Bulletin Number: TB-211201

Subject: PH53W-A and PH52W-A Seal Kit Part Number: P52W-X801

Scope: 5kW Engine Heaters

Seal Kit

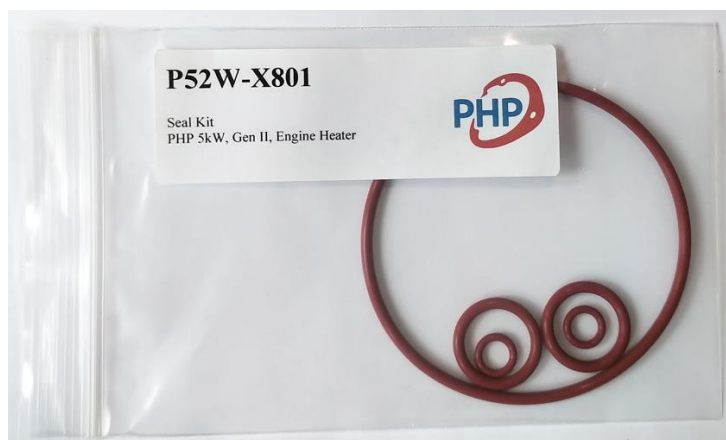
In some instances, the P53W-T801 and P52W-T801 heater to have premature failure of “O” Ring seals which can result in coolant leaking.

Several known causes are overheating, contaminated coolant and in some cases, faulty seal materials.

A seal kit has been developed which includes all required seals for this heater.

These seals are made from Viton which improves their ability to withstand higher temperatures while maintaining their sealing properties.

- 1 of Heat Exchanger “O” Ring
- 2 of Temperature Sensor “O” Rings
- 2 of Inlet /Outlet Port “O” Rings

Future production units will be upgraded with high temperature “O” Ring Seal materials.
